APPEAL SUMMARY

| Appeal ID: 20429 | Project Address: 8212 N Denver Ave |
| Project Type: commercial | Stories: 2 Occupancy: B AND R-2 Construction Type: V-N |

APPEAL INFORMATION SHEET

SECOND FLOOR PLAN

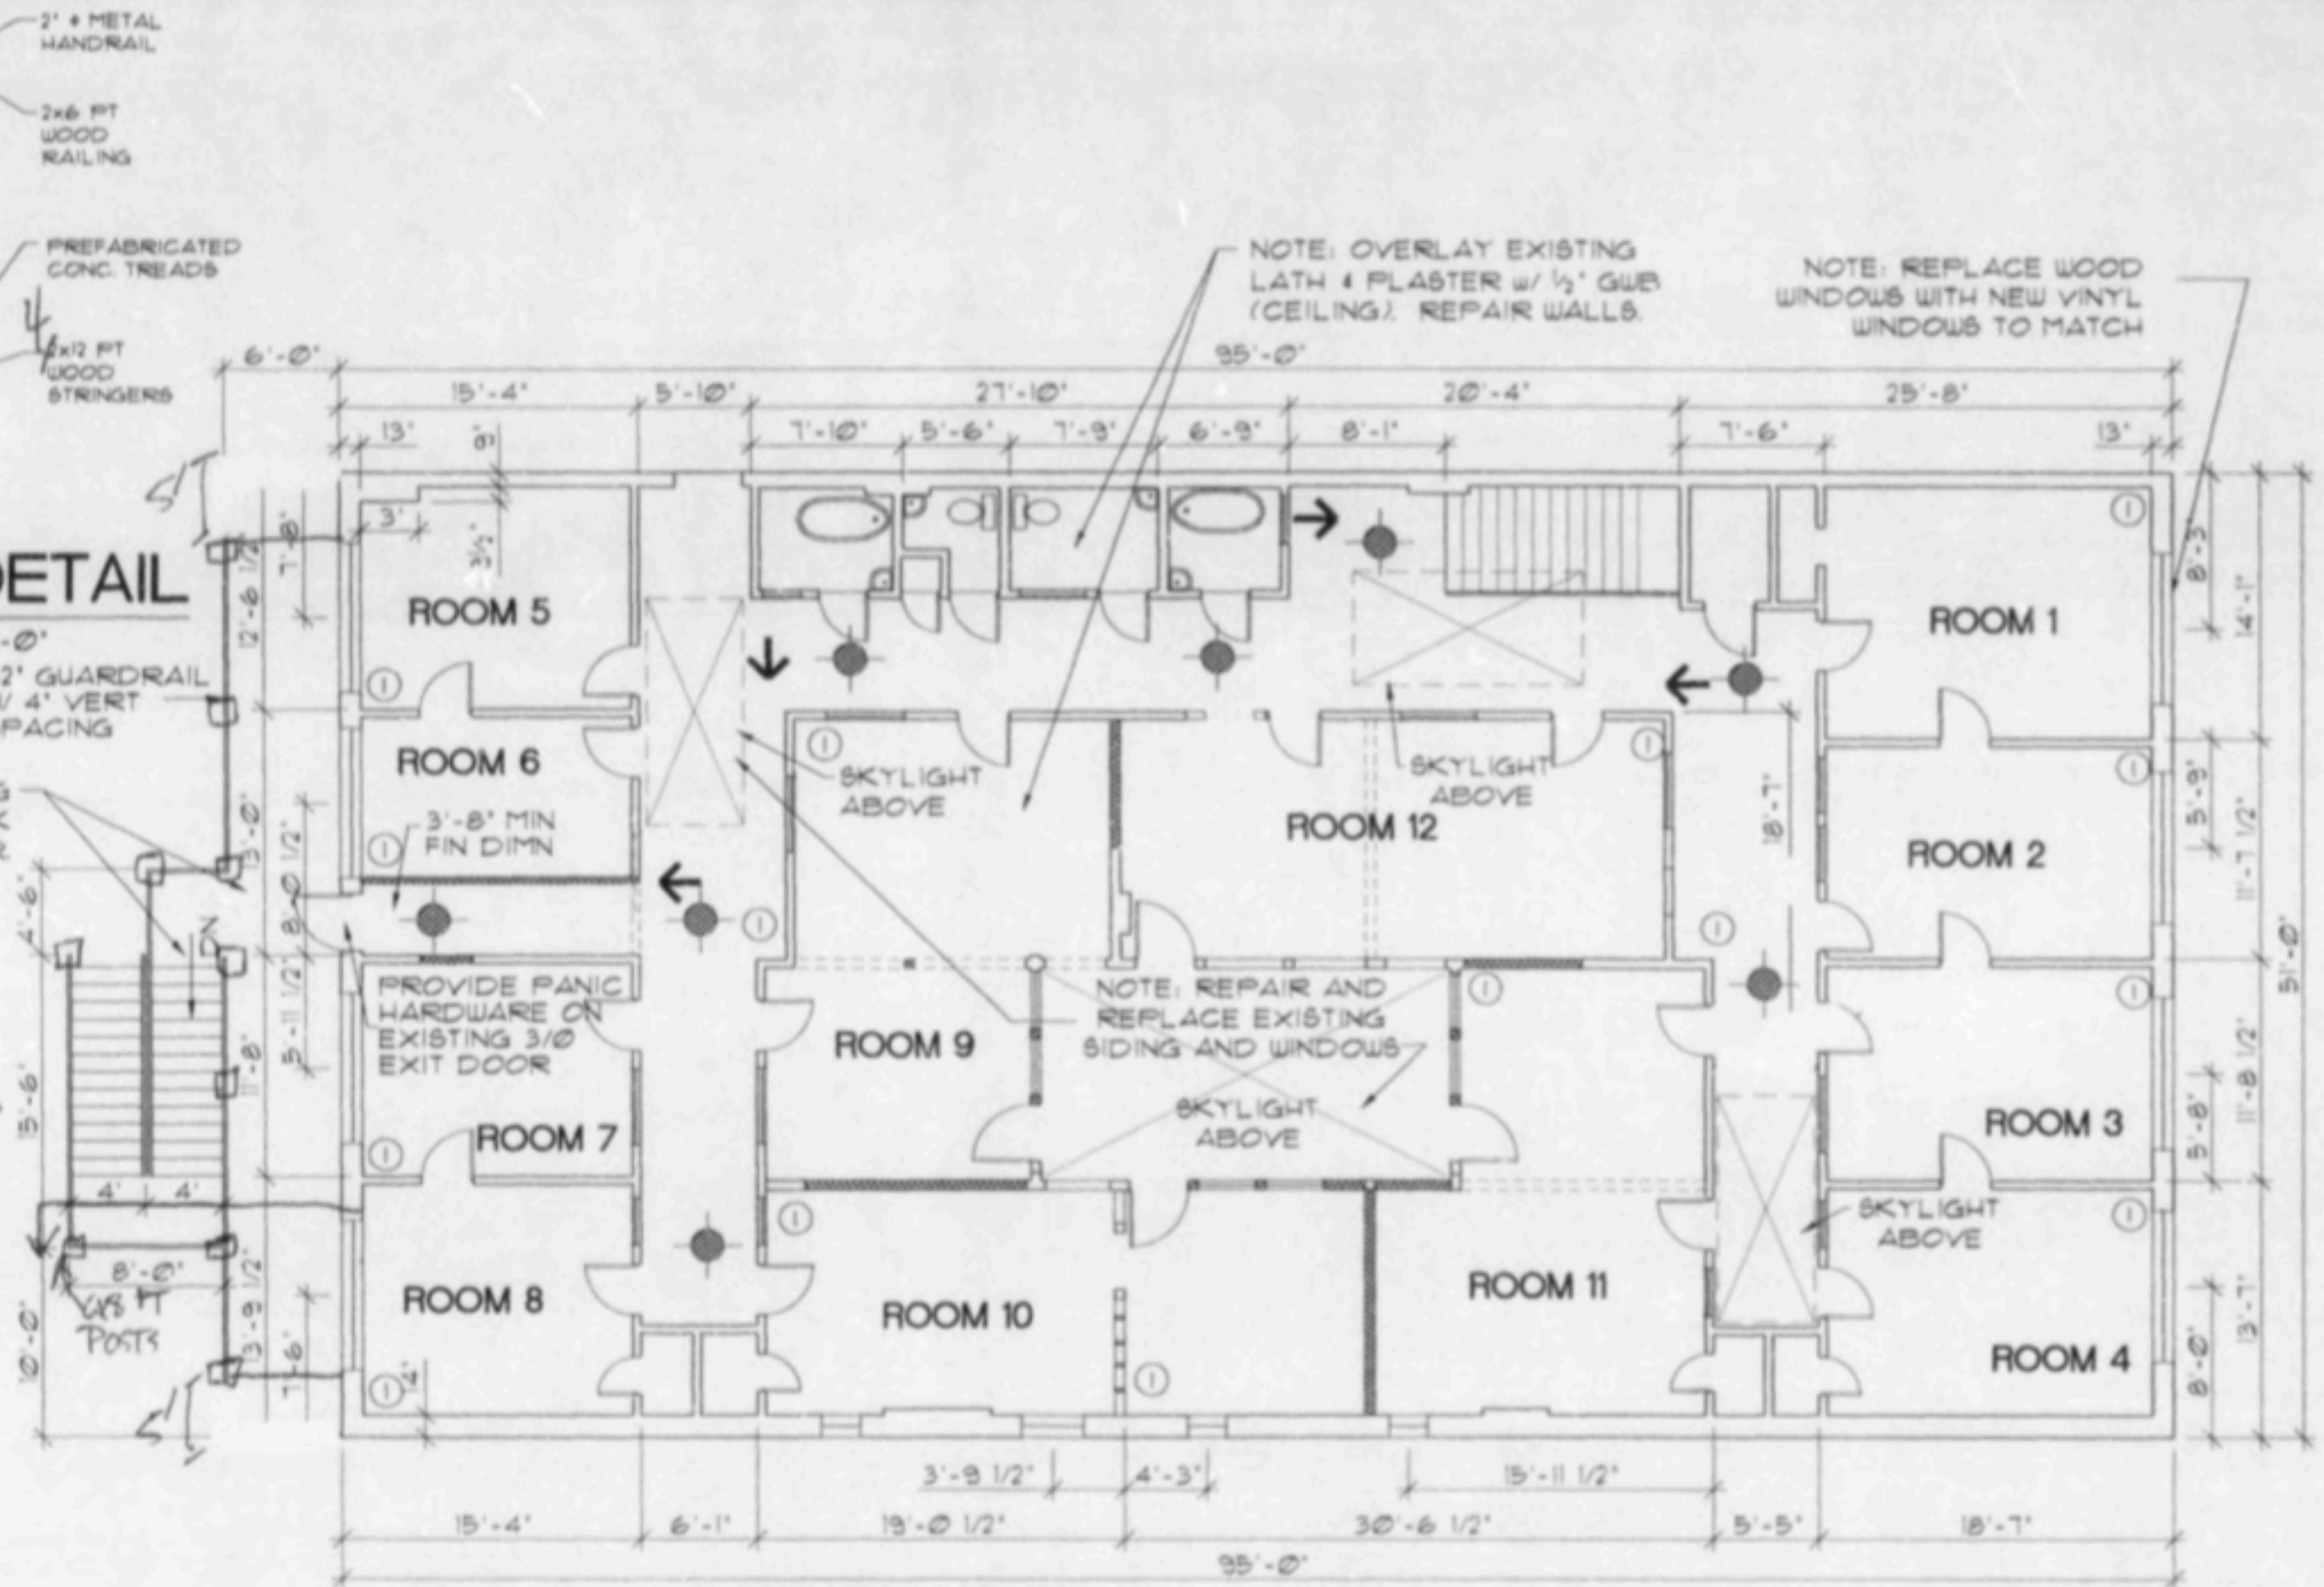
| Requires | <p>This is two-story structure with R-2 apartments on the second floor, and retail on the ground level.</p> <p>There had been a dispute about the number of existing units for this building on the 2nd floor. There is a clearly documented, approved, and finaled permit and set of plans on record showing that brought the floor from 16 units down to 12 units (00-150160). The scope of work was completed and this plan also matches up to the current conditions of the building.</p> <p>However there was an obscure poorly documented revision with very minimal records and no definitive plans that proposed 8 units. This has created some confusion.</p> <p>But upon further review of the records by the inspections department, myself, and others, subsequent approved and finaled plans were located for a Fire Protection System permit that clearly show 12 units. S011329 is the most clear inspection record noting 12 units on the 2nd floor. Issued on 8/23/10, and having final inspection approval on 6/7/02, its the most recent approved permit that documents and substantiates 12 units.</p> <p>So I have been instructed to get an appeal at this point so an official confirmation of 12 units can be on record.</p> |

- 1. Determination of 2nd floor layout as existing: Granted as proposed.**
- 2. Omission of requirement for construction document preparation by a registered design professional: Denied per ORS 671.030(2)(d).**
- 3. Sound transmission ratings (STC / IIC) for 1 hour rated floor / ceiling assembly: Hold for Additional information.**
